# MIAMI BEACH

Staff Report & Recommendation

SUBJECT: HPB20-0380, **550 Washington Avenue.**

An application has been filed requesting a Certificate of Appropriateness for the partial demolition and renovation of the existing building including the construction of attached additions and modifications to original public interior spaces and a variance to exceed the maximum permitted building height.

550 Washington Avenue, partial south elevation, Permit No. 21003

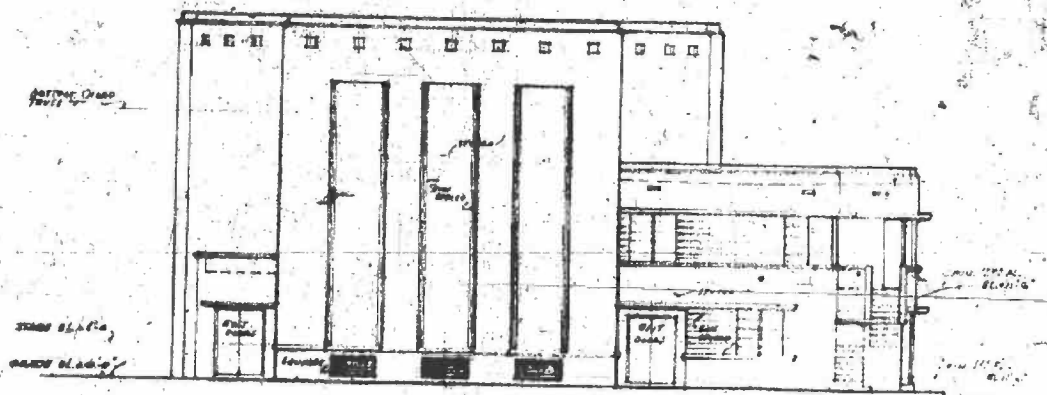
Finally, a 1-story ground level addition is proposed to be constructed on the south side of the building adjacent to the original 8-unit apartment portion of the building. The south wall at the ground level of the apartment building is proposed to be removed in order to allow for the expansion of the kitchen area into the new addition. Although the construction of this new addition will substantially obscure the ground level south façade, staff would note that the second floor exterior corridor of the south elevation, with decorative pipe columns, is proposed to be retained. Additionally, staff is recommending that both levels at the western end of the building be restored

in a manner consistent with available historic documentation, including original windows openings, muntin configurations and horizontal banding between window openings. Further, staff recommends that the proposed mechanical screening at the roof of the original apartment building be setback a minimum of 20'-0" from the Euclid Avenue property line.

- c. The westernmost portion of the original apartment building shall be restored consent with available historic documentation including original windows openings, muntin configurations and horizontal banding between window openings, in a manner to be reviewed and approved by staff consistent with the Certificate of Appropriateness Criteria and/or the directions from the Board.
- d. The proposed mechanical screening at the roof of the original apartment building shall be setback a minimum of 20'-0" from the Euclid Avenue property line, in a manner to be reviewed and approved by staff consistent with the Certificate of Appropriateness Criteria and/or the directions from the Board.
